Technical Note

Project Mayfield Appointments 2020
Subject Information to Support Discharge of Condition 66 – Application Ref. 124972/FO/2019
Project no 0046688
Date 20 April 2021

Revision	Description	Issued by	Date	Approved (signature)
00	Issue to LPA	RG	18/12/2020	CB
01	Issue to LPA	JF	06/02/2021	CB
02	Update following EA approval of hydraulic modelling	JF	10/03/2021	CB
03	Update following EA review	JF	20/04/2021	CB

Figure 1: Baseline water level at the Wildscape area, annotated with location of cause of mass error

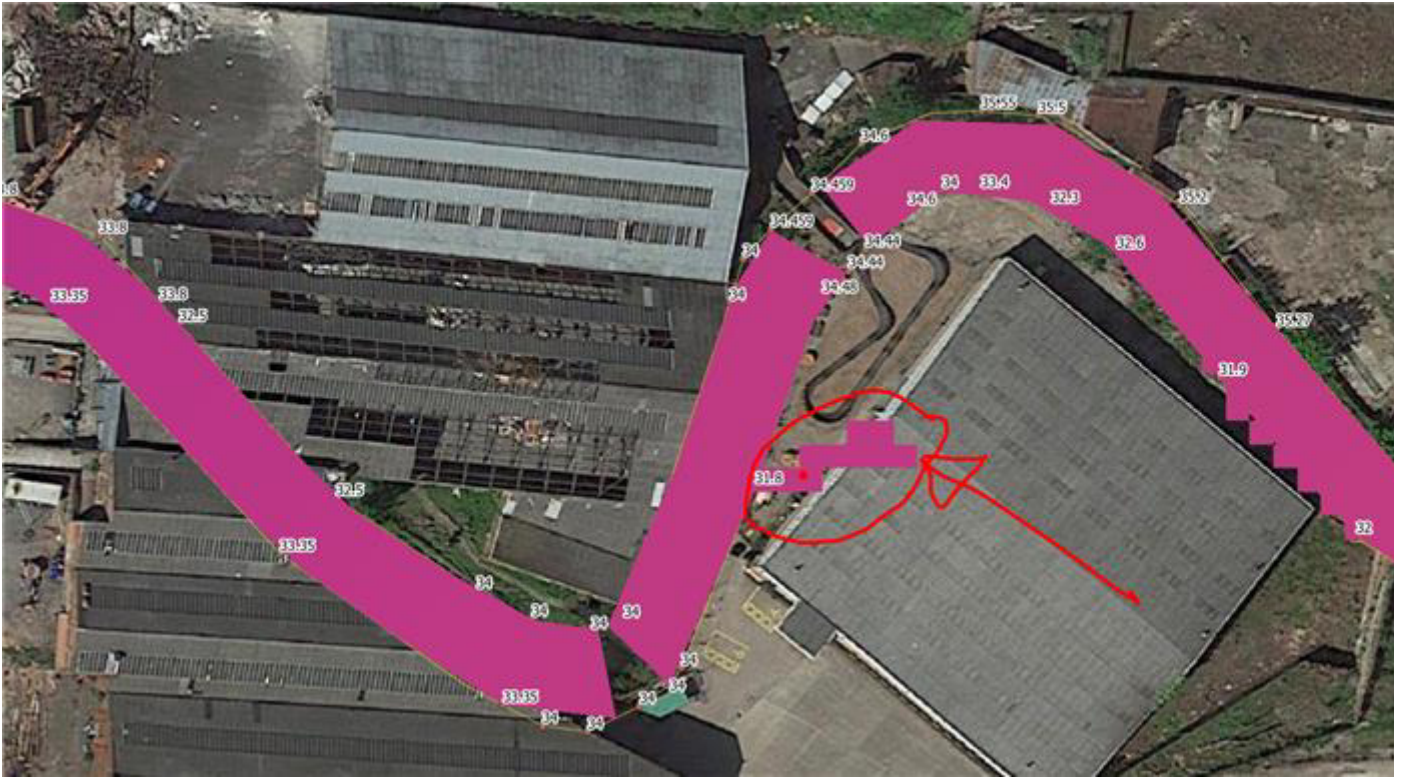
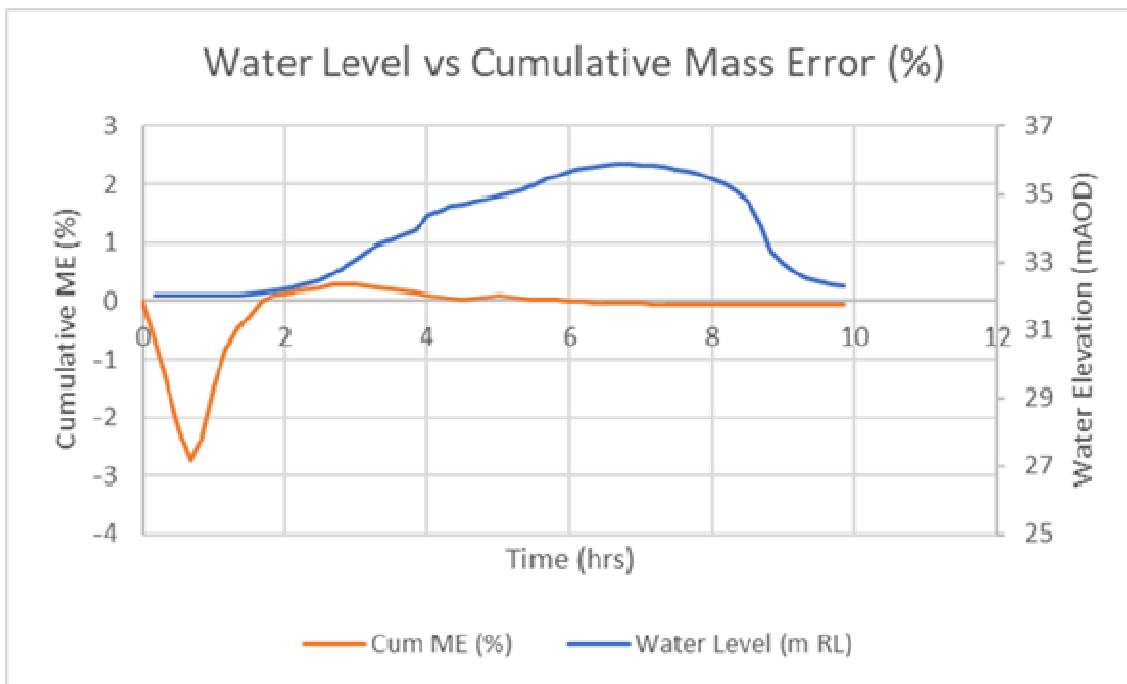
We have been investigating the mass balance error with regard to Item 14.1 in the model review spreadsheet, and thought it would be helpful to provide an update in advance of reissuing our deliverables formally.

- Accumulation of mass error occurs between the hours of 0 and 2, when flow in the river is low, and in-channel water levels are very similar to the low point of the bank;
- This causes constant flux between the 1D and the 2D domains at the part of the Wildscape area circled in the image in Figure 1, with no clear dominant flow direction;
- Concluded that this flux is the cause of the peak in mass error, as cumulative mass error begins to reduce as water levels increase (Figure. 2).

- Raise bank height from 31.8mAOD to 32mAOD locally, at inflow point from channel to Wildscape area, to match proposed level for low point of Wildscape area
- This prevents movement between 1D and 2D domain during low flow state (hours 0 to 2) and significantly reduces the mass error (Table 1 and Figure 3)
- This amendment is considered a more accurate representation of the proposed scheme, rather than a design change, and does not have an impact on water levels elsewhere within the model

Figure 3: Comparison of cumulative mass error for the 100 year + 35% CC event for the Baseline and Full Build Out models

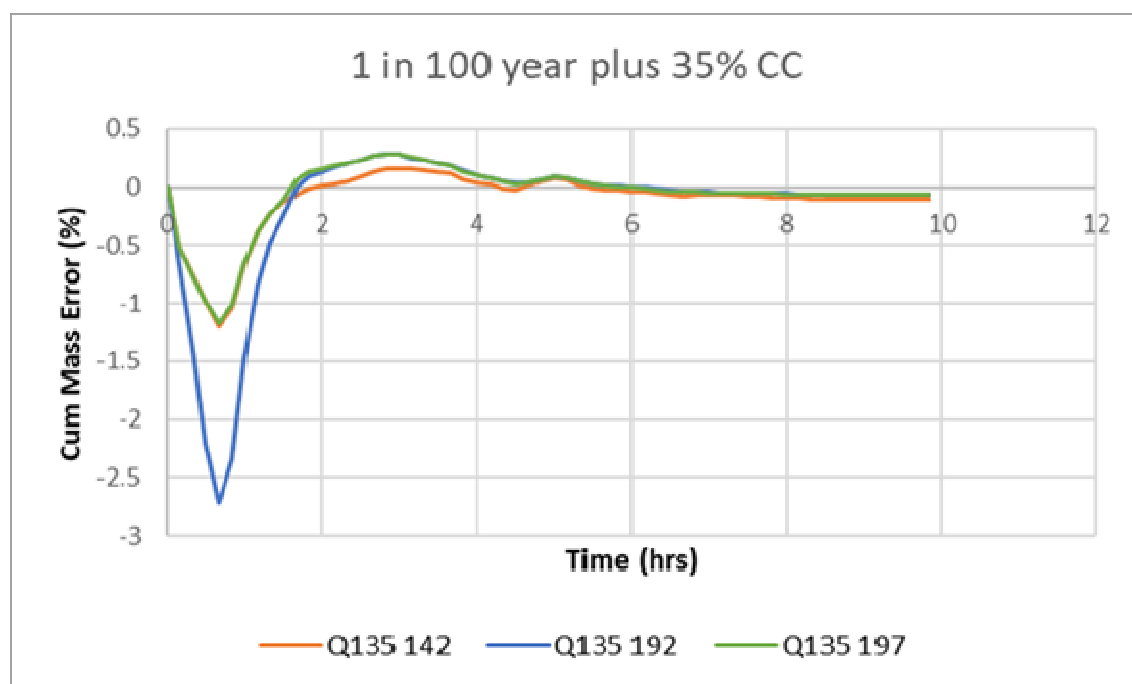
- **The 1D channel cross sections and structures do not appear to match the plans provided.**
- **2D mass balance error is out of tolerance (+/-1%) indicating model instability. This should be reviewed and improved.**

Event	Baseline (142)	Full Build Out (192)	Amended Full Build Out (197)	
25 year	1.19%	2.78%	1.19%	Matches baseline
100 year	0.95%	2.41%	0.98%	Less than 1%
100 year + 35% CC	1.19%	2.72%	1.16%	Less than baseline
